Central Subpopulation of Northern Anchovy

STAR Panel Meeting Report

Online
December 7-10, 2021

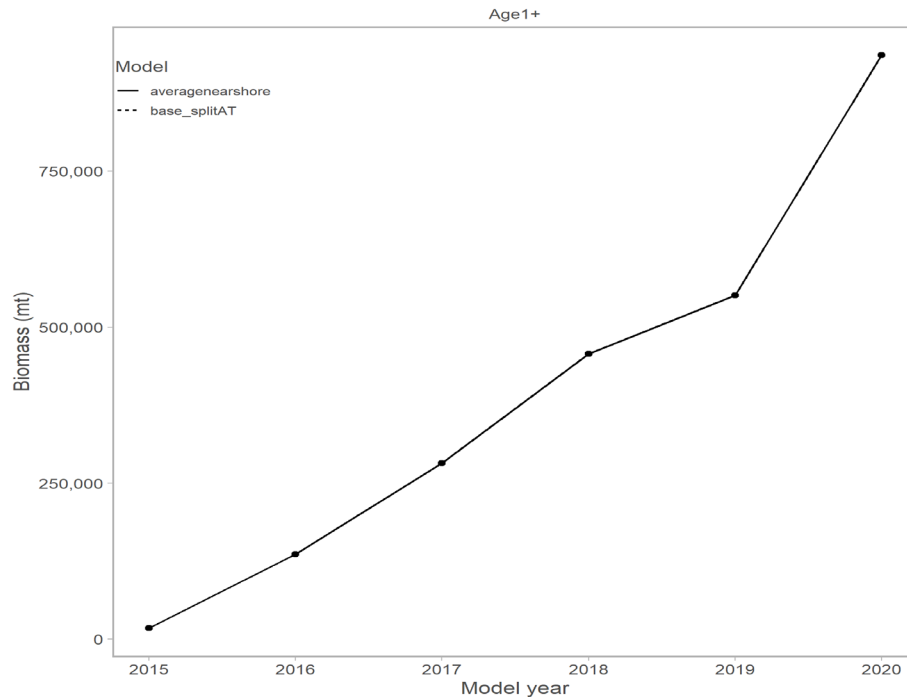
Request 22: Conduct a sensitivity analysis using alternative values for the AT survey catchability Q informed by estimates of the proportion of biomass inshore of the AT survey based on the average of the aerial and nearshore acoustic surveys.

Rationale: This analysis is intended to use small vessel acoustic survey and aerial survey data to inform catchability, accounting for the proportion of the abundance unaccounted for in the area shoreward of the AT survey.

Response: There were only two cruises with overlap in both small vessel and aerial nearshore observations (Summer 2019 [1907] and Spring 2021 [2104]).

A table was created with the fraction of the biomass estimated nearshore.

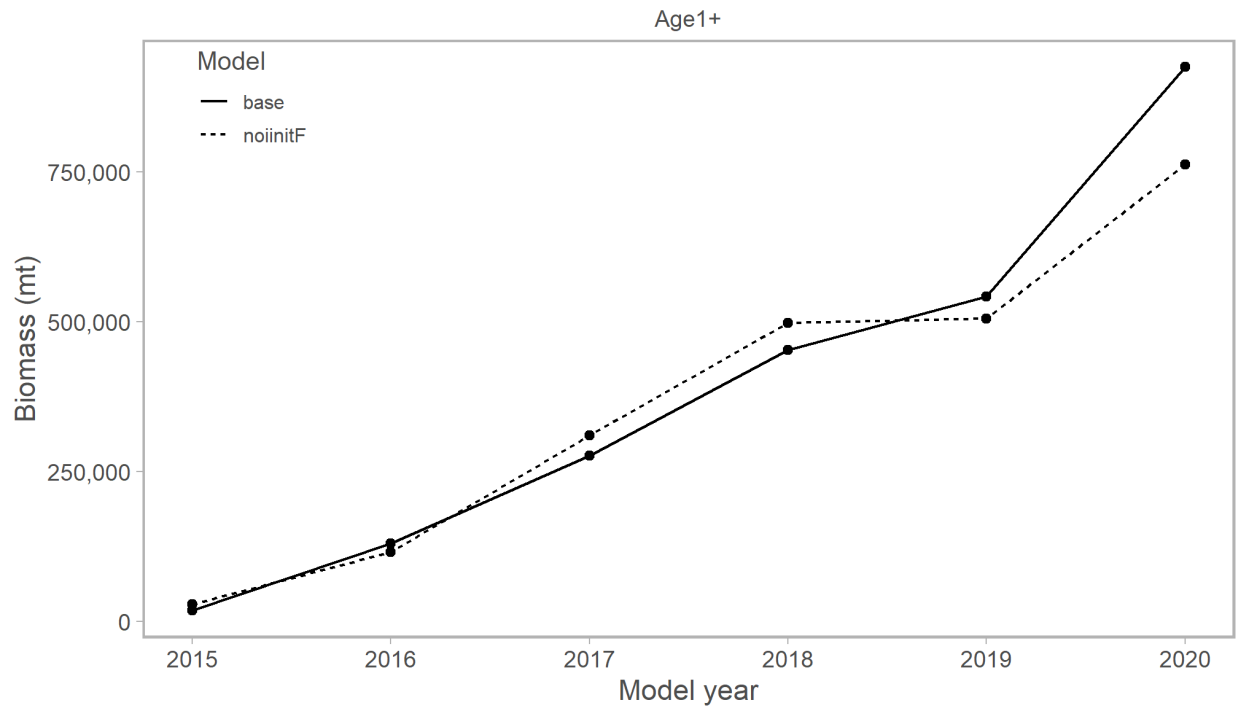
Request 24: Perform a run of the base model that does not estimate initial F.

Rationale: It was hypothesized that initial F and the R_0 offset parameters were to some extent redundant, and the initial F estimate from the base model seemed suspect.

The fit of the model (as indicated by the change in negative log-likelihood) got appreciably poorer (7 log-likelihood units), supporting continued estimation of all three parameters (R_0 , R_0 offset, and initial F).

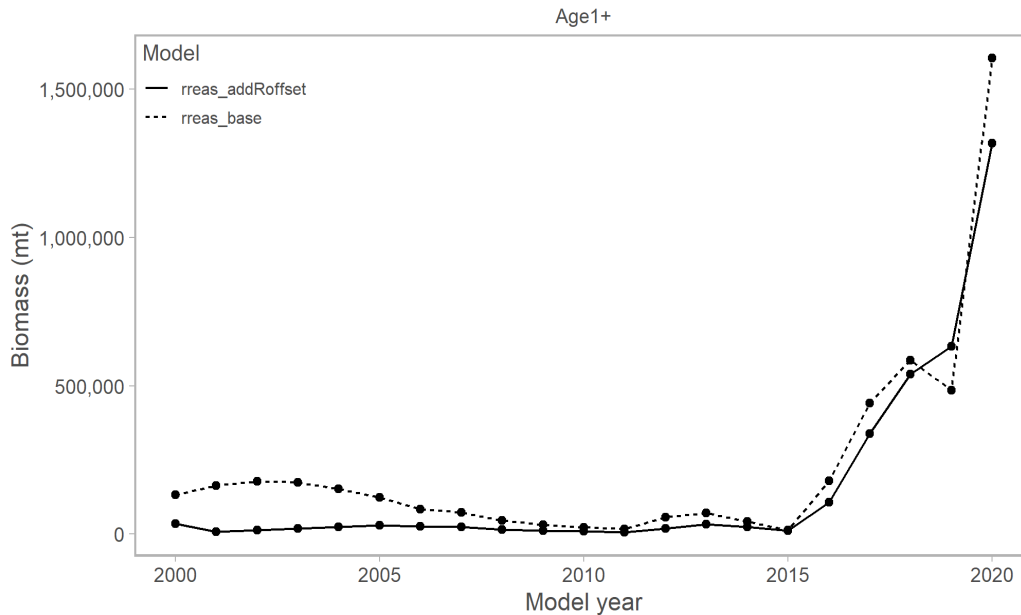
Request 25: Perform a run of the extended RREAS model that does not estimate initial F but does estimate offset in R_0 .

Rationale: It was hypothesized that the two parameters were redundant.

The model results in high fishing mortality rates, odd selectivities that change substantially among years, a similar fit to indices, and a very low M ($\sim 0.25\text{yr}^{-1}$). The STAT and Panel agreed that all three parameters determining the initial size should be estimated.

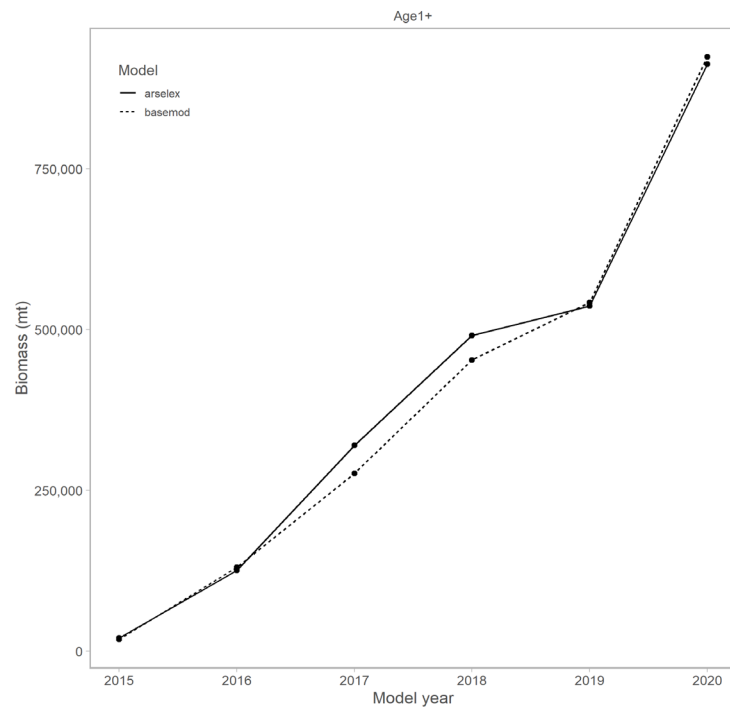
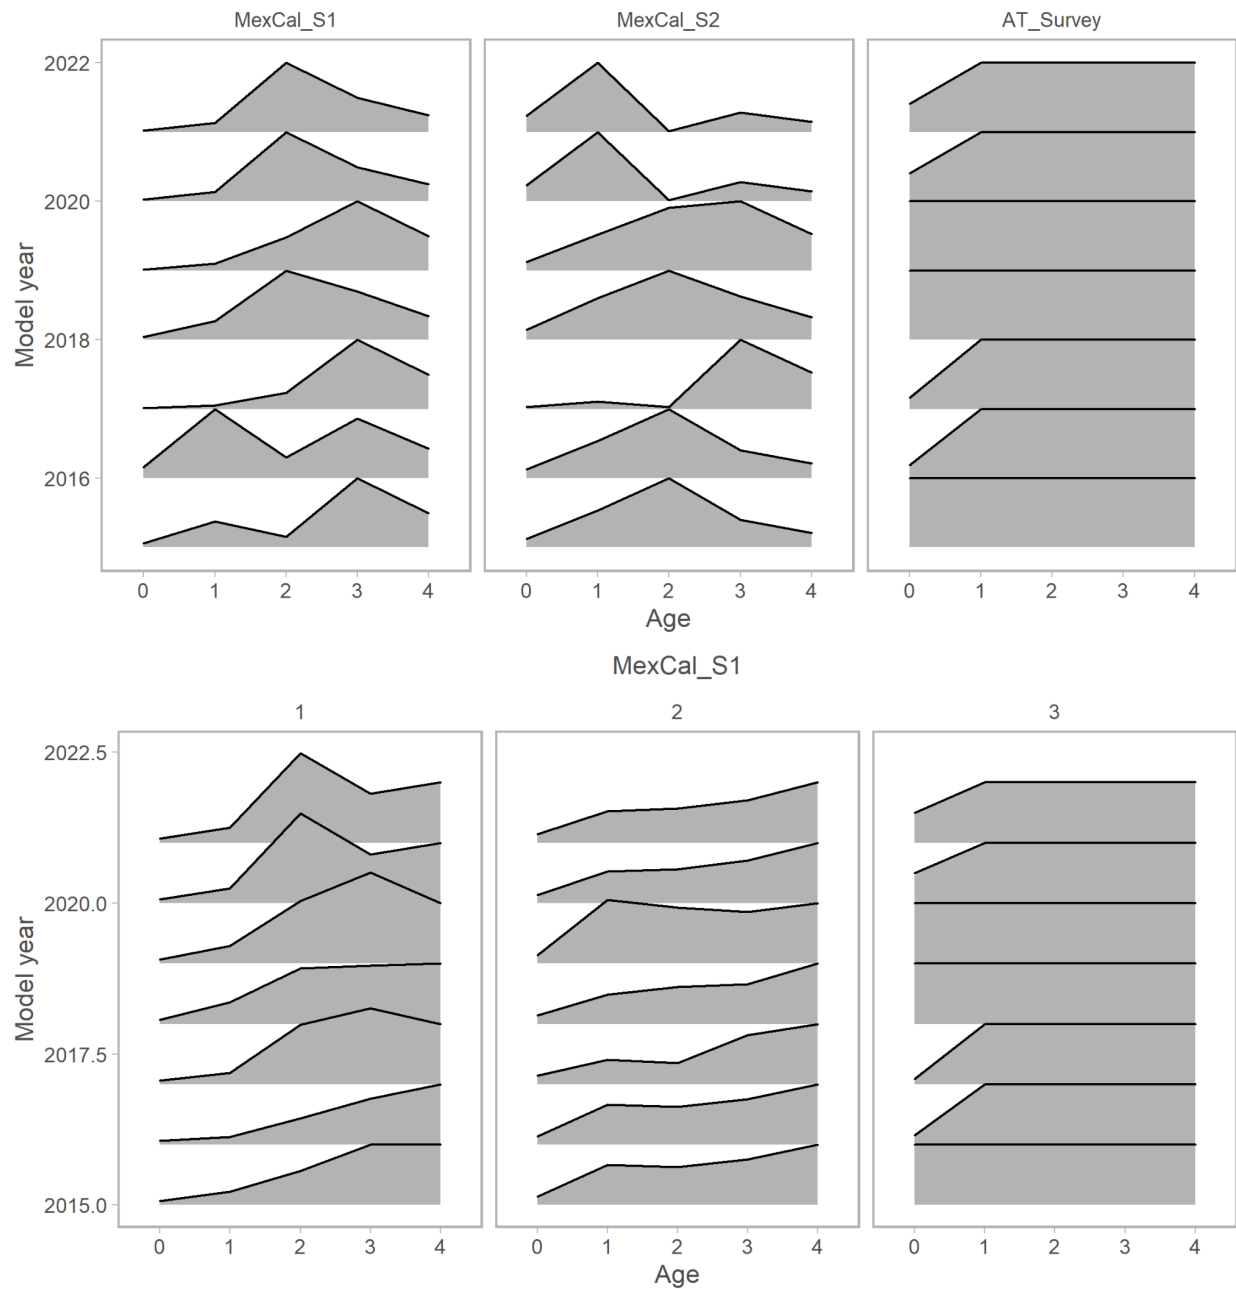
Request 26: Explore selectivity parameterizations where the ratio of selectivity for age-0 vs age-1 is not fixed (consider the 2dAR option in SS, which combines flexibility with a penalty for too much deviation). Consider combining this change to the model specifications with changing the data plus group to ages 3+.

Rationale: It did not seem reasonable to expect a fixed ratio between selectivity for age-0 and age-1 to apply in all years, although allowing complete flexibility may result in model instability.

Response: The analysis suggests that a penalized selectivity pattern leads to what the STAT and Panel considered more realistic selectivity patterns, but with little impact on the overall results (similar biomass trajectories and similar, but possibly slightly improved, fits to data).
